## Product Change Notice (PCN)

PCN Number: PCN-0450890R-01

Product(s) Affected: *SJ1-351X-SMT Series (SJ1-3513-SMT-TR, SJ1-3514-SMT-TR, SJ1-3515-SMT-TR, SJ1-3515-SMT-TR-BE, SJ1-3515-SMT-TR-GR, SJ1-3515-SMT-TR-PI)*

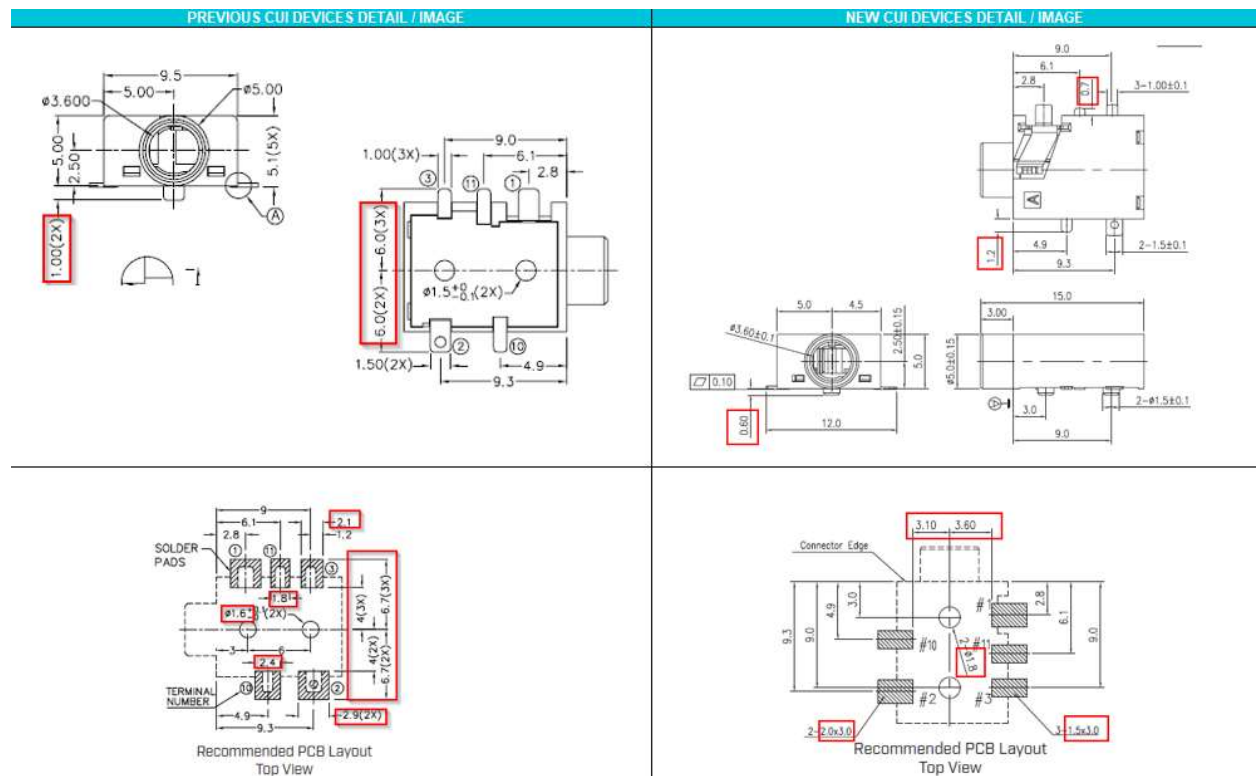
Description of Change: *Minor Housing and footprint differences. Material Change on the housing and terminals. See image Below*

PREVIOUS CUI DEVICES DETAIL / IMAGE			NEW CUI DEVICES DETAIL / IMAGE		
	MATERIAL	PLATING	DESCRIPTION	MATERIAL	PLATING/COLOR
terminal 1	copper alloy	gold flash	terminal 1	phosphor bronze t=0.30	gold flash over nickel
terminal 2	copper alloy	gold flash	terminal 2	phosphor bronze t=0.20	gold flash over nickel
terminal 3	copper alloy	gold flash	terminal 3	phosphor bronze t=0.20	gold flash over nickel
terminal 10	brass	gold flash	terminal 10	brass t=0.20	gold flash over nickel
terminal 11	brass	gold flash	terminal 11	brass t=0.20	gold flash over nickel
plastic	PA10T		cover	PAST (UL94V-0)	see color options
			housing	PAST (UL94V-0)	see color options
